SR 400/Interstate 85 Connector Ramps

Project No. NH000-0085-02(153)

Value Engineering Study Report

Concept Design Submittal

Sketch Alt. AS-1
2/5

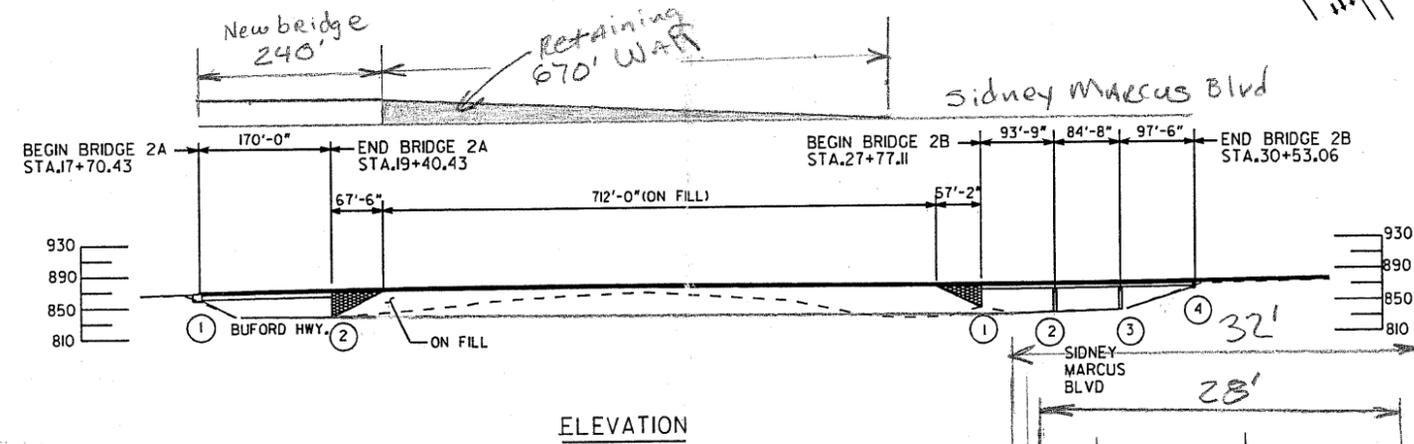
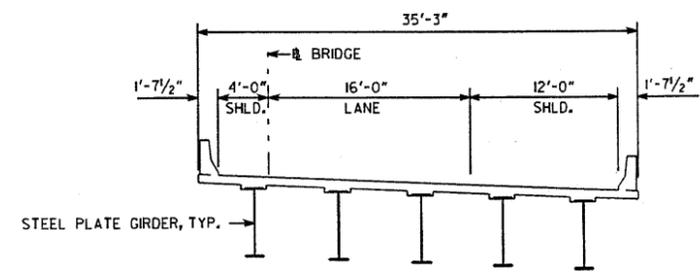
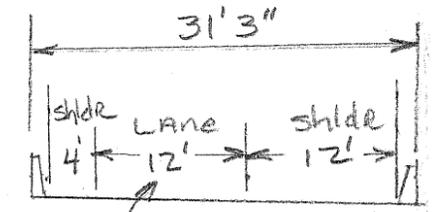
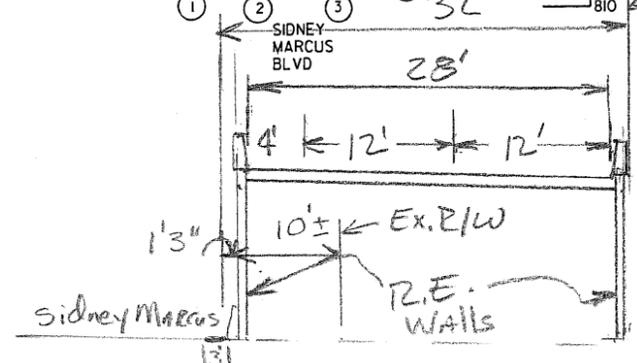
Alt. Design "ZA"
12' Lane is sufficient for tangent alignment & slower speed.

Alt. Design "2B"
Section at R.E. WALLS.

Alternate
Sketch 2/5
Alt. AS-3, AS-4

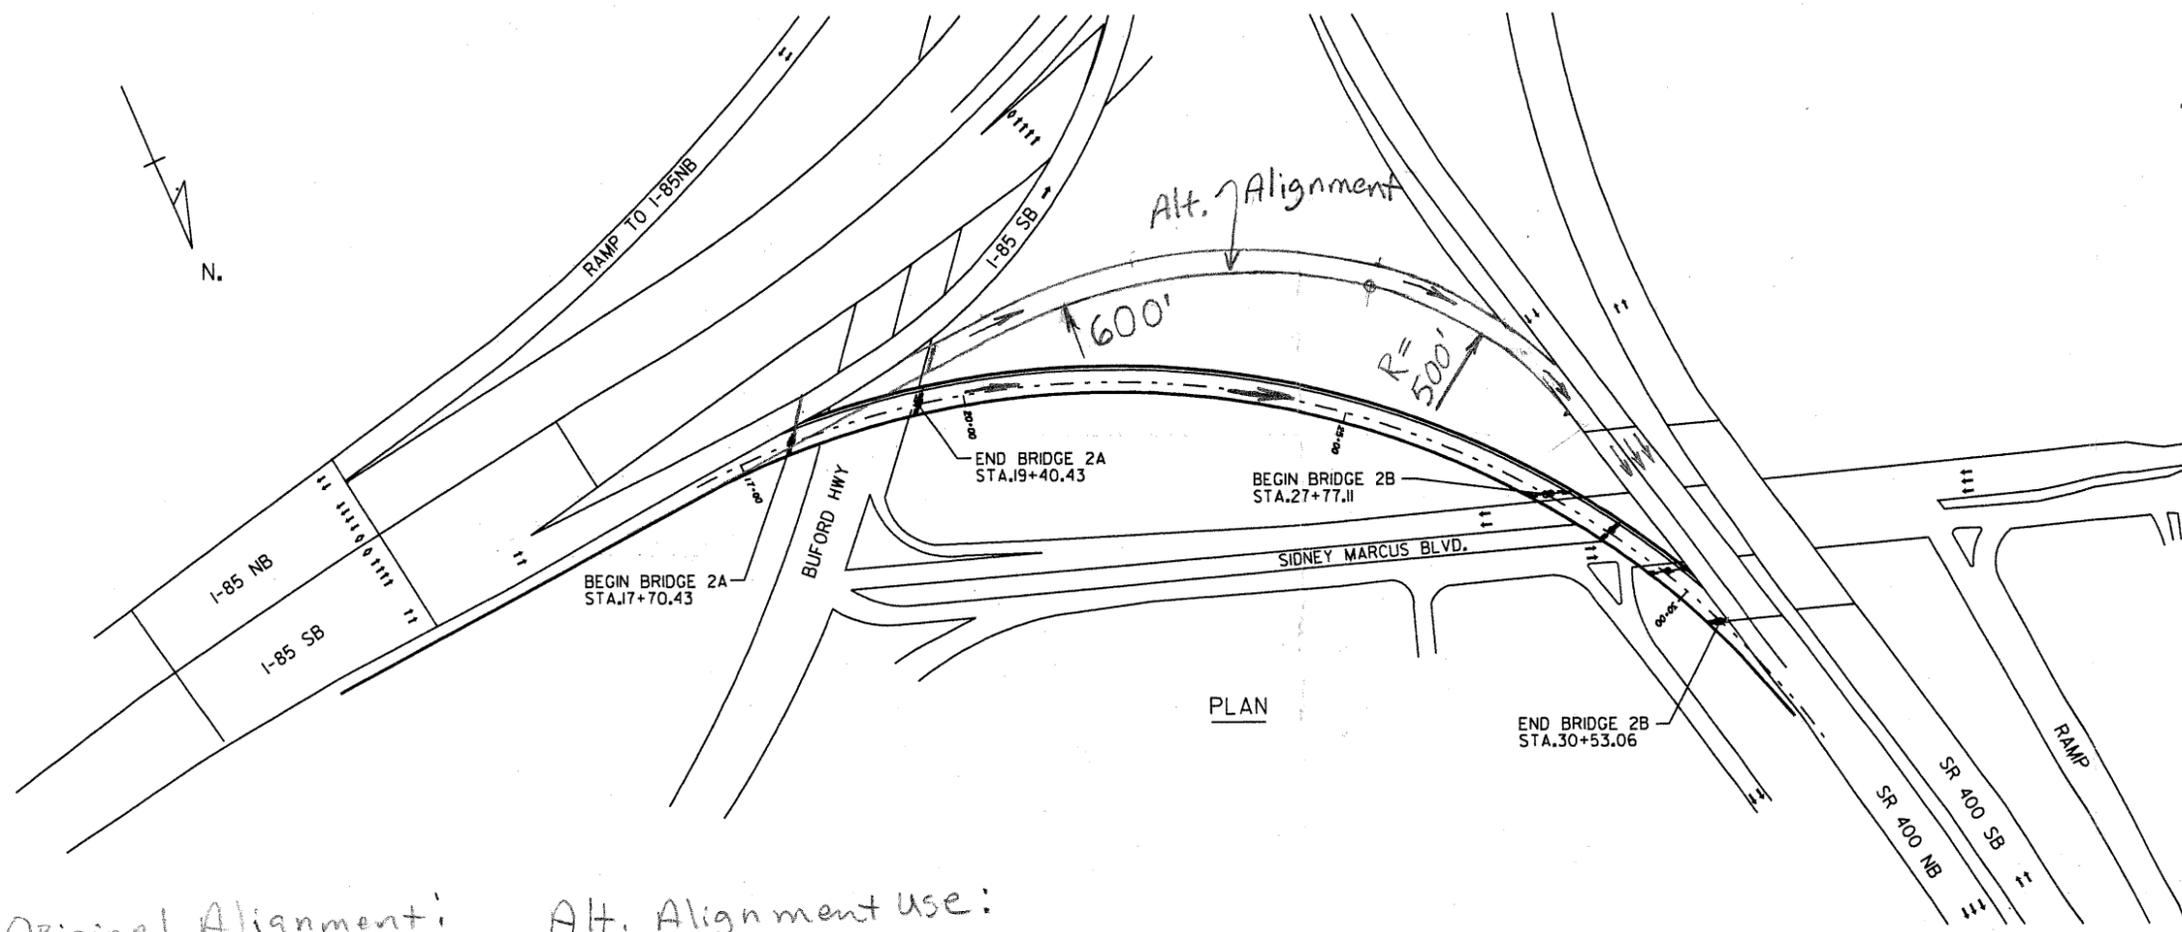
Original Alignment:
R = 1,130'

Alt. Alignment Use:
Compound Radii
R₁ = 600' & R₂ = 500'

Buford Hwy
Alt. Bridge is
Longer due to more skew.

ALTERNATIVE NO.:
SS-1

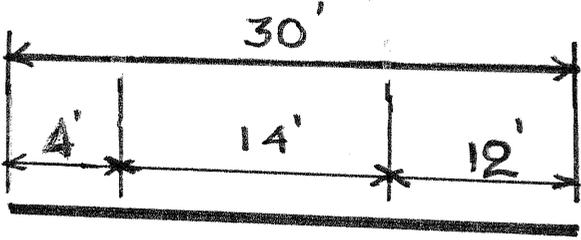
Per AASHTO Exhibit 3.50, the minimum width needed for an 18 wheel trailer (WB-65) on a single-lane road and one-way conditions is 26-ft, allowing for a stalled vehicle to be passed by another of the same type. The proposed 30-ft-wide section more than meets this requirement. It may be of some advantage if the allowable speed is reduced from 45 mph to 35 mph.

55-2

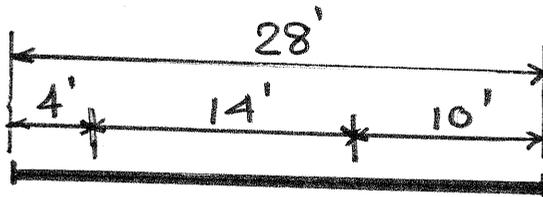
PROJECT: SR 400/INTERSTATE 85 CONNECTOR RAMPS <i>Project No. NH000-0085-02(153) - Fulton County, Georgia</i> Concept Report	ALTERNATIVE NO.: SS-2
DESCRIPTION: USE A 28-FT-WIDE SECTION WITH 14-FT-WIDE TRAVEL LANE FLANKED BY 4-FT AND 10-FT WIDE SHOULDERS IN LIEU OF THE 32-FT-WIDE SECTION	SHEET NO.: 1 of 4

ALTERNATIVE NO.:
SS-3

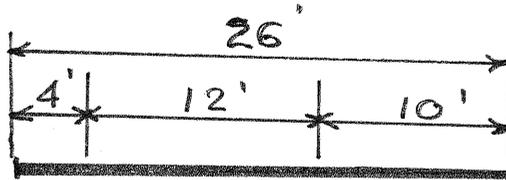
Per AASHTO Exhibit 3-50, the minimum width needed for an 18 wheel trailer (WB-65) on a single-lane road and one-way conditions is 26 ft, allowing for a stalled vehicle to be passed by another of the same type. The proposed 26-ft-wide section meets this requirement.

Shorten Bridge Over Buford Hwy (E-85 side) SHEET NO.: 2 of 4

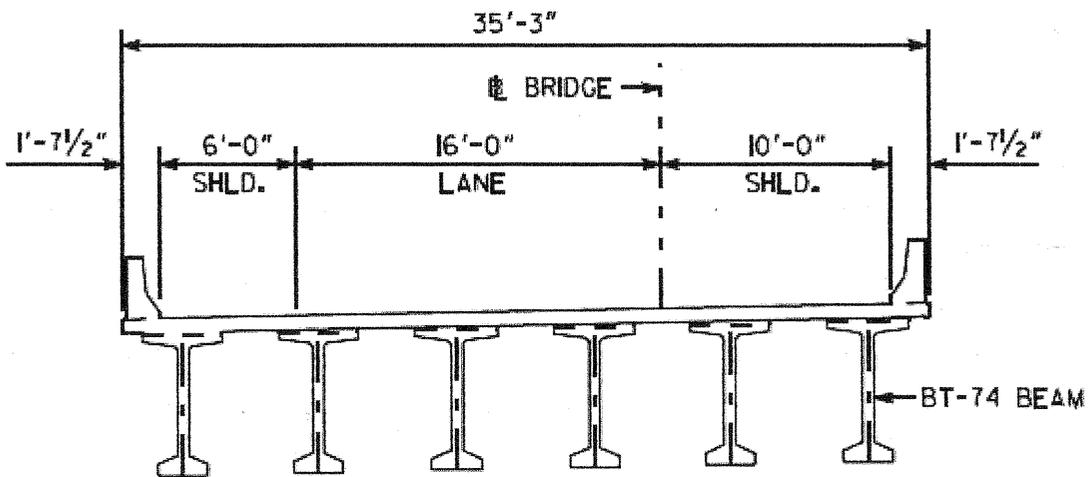
Readjusting the span lengths to 165 ft allows the use of the more economical precast bulb tee girders. This could be done by an alignment change to flatten the skew over Buford Highway or by using a compound curve. Another solution to reduce the length would be to move the end bent closer to Buford Highway. The use of high strength (10,000psi) concrete will be necessary to meet the required load carrying capacity.

$$\text{Current} = 170' \times 35'-3" \times 160 \frac{\$}{\text{SF}} \underset{\text{(Steel)}}{=} = \$958,800$$

$$\text{Proposed} = \text{Say } 165' \times 35'-3" \times 140 \frac{\$}{\text{SF}} \underset{\text{(74 BT)}}{=} = \$814,275$$

SN-1

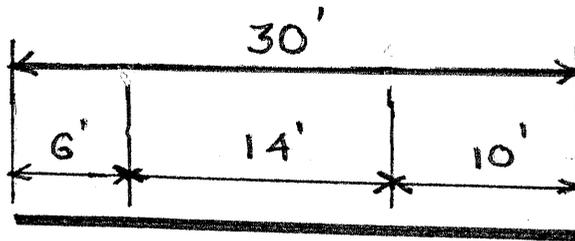
COST SUMMARY	INITIAL COST	PRESENT WORTH RECURRING COSTS	PRESENT WORTH LIFE-CYCLE COST
ORIGINAL DESIGN	\$ 16,605,120	—	\$ 16,605,120
ALTERNATIVE	\$ 14,655,939	—	\$ 14,655,939
SAVINGS (Original minus Alternative)	\$ 1,949,181	—	\$ 1,949,181

SN-2

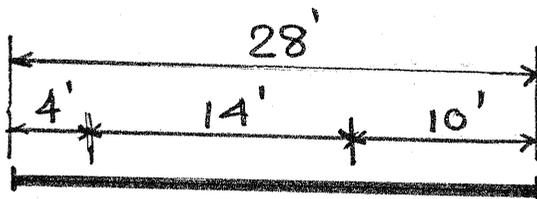
Per SN-1 calculation sheet, 86,418 sf

ALTERNATIVE NO.:
SN-3

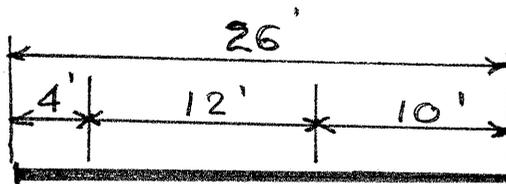
Per AASHTO Exhibit 3.50, the minimum width needed for an 18-wheel trailer (WB-65) on a single lane road and one way conditions is 26 ft, allowing for a stalled vehicle to be passed by another of the same type. The proposed 26-ft-wide section meets this requirement.

400 SOUTHBOUND TO I-85 NORTHBOUND

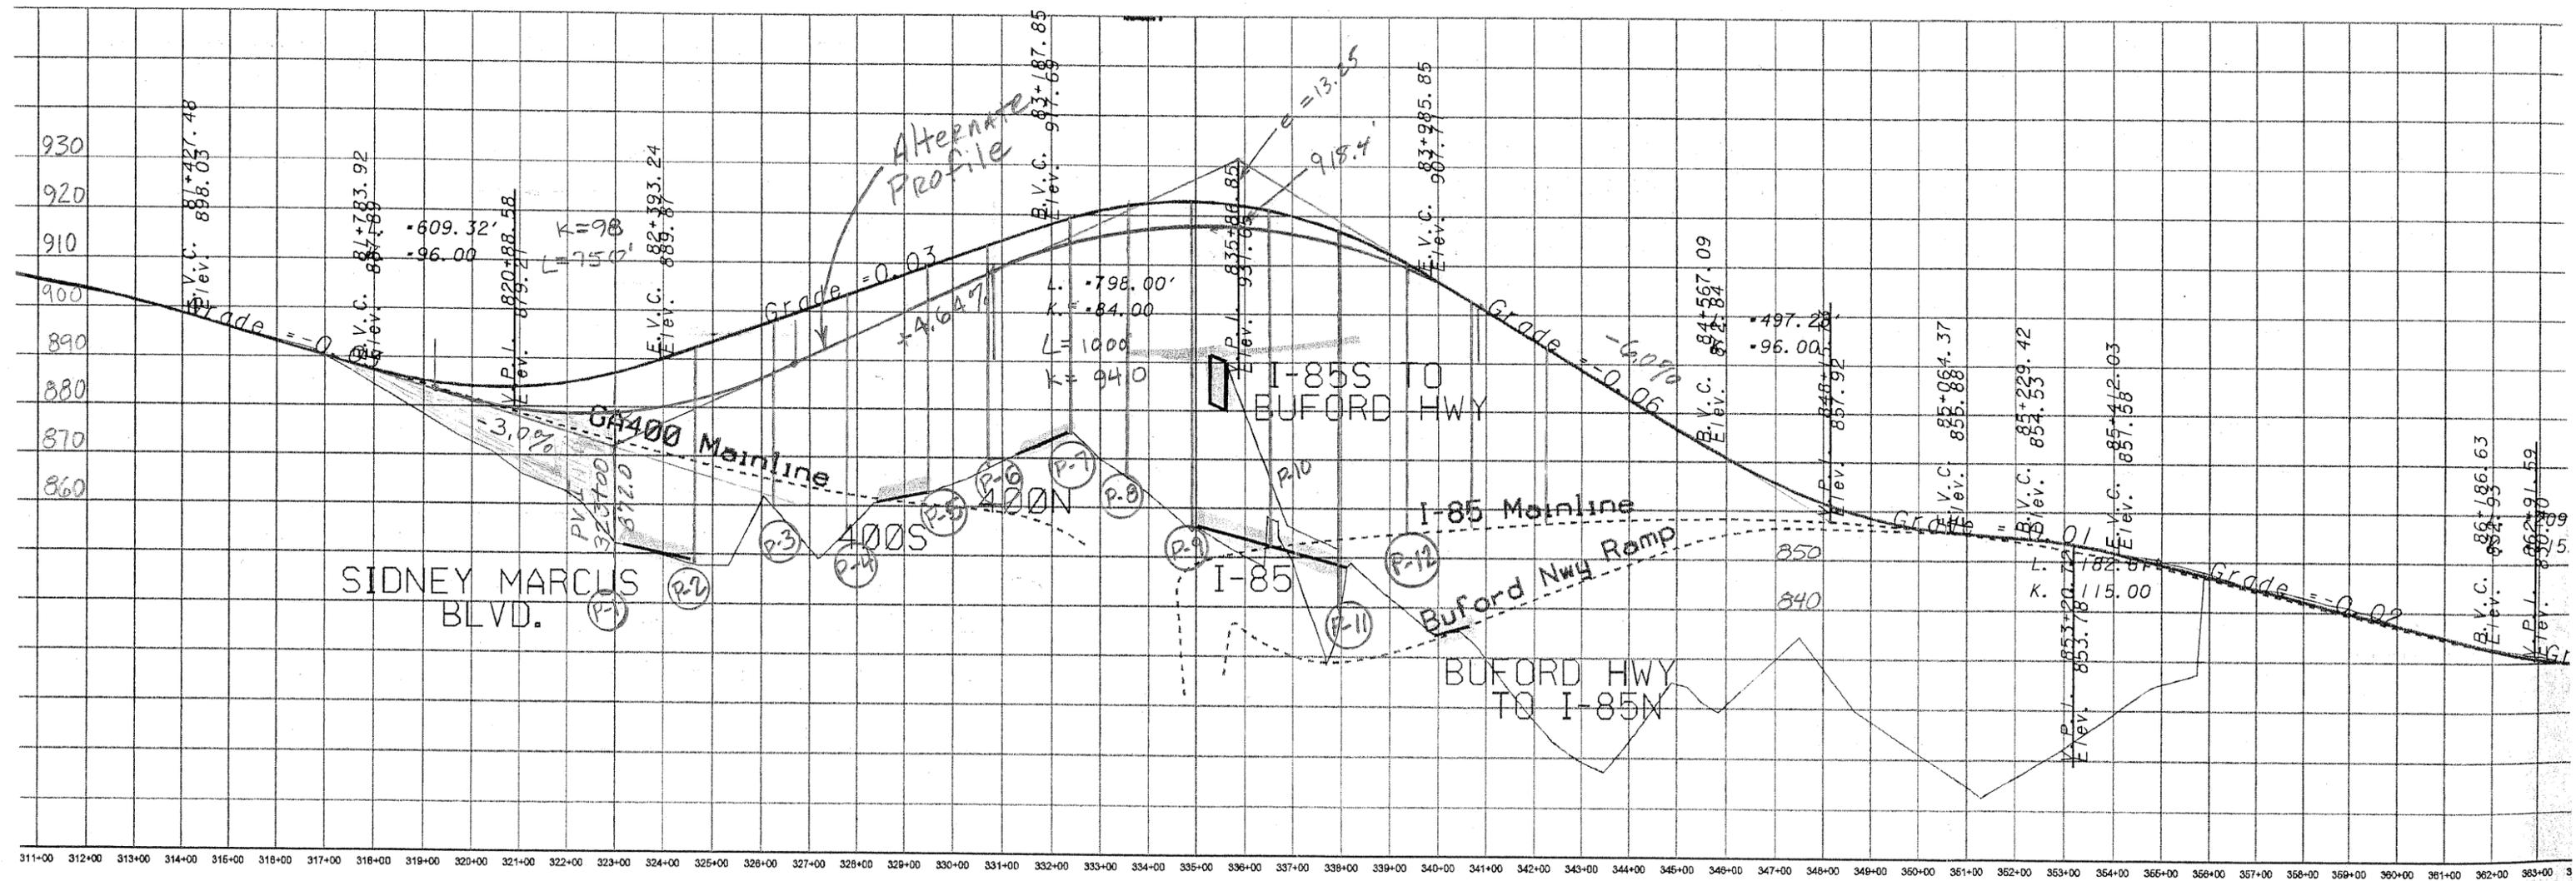
Lowering the profile for SR 400 SB to I-85 NB ramp would shorten the bridge columns, reducing the amount of steel and concrete. A total of 62LF of columns can be saved by lowering the profile. This will also save on construction time, beam placement, and overall access to the structure.
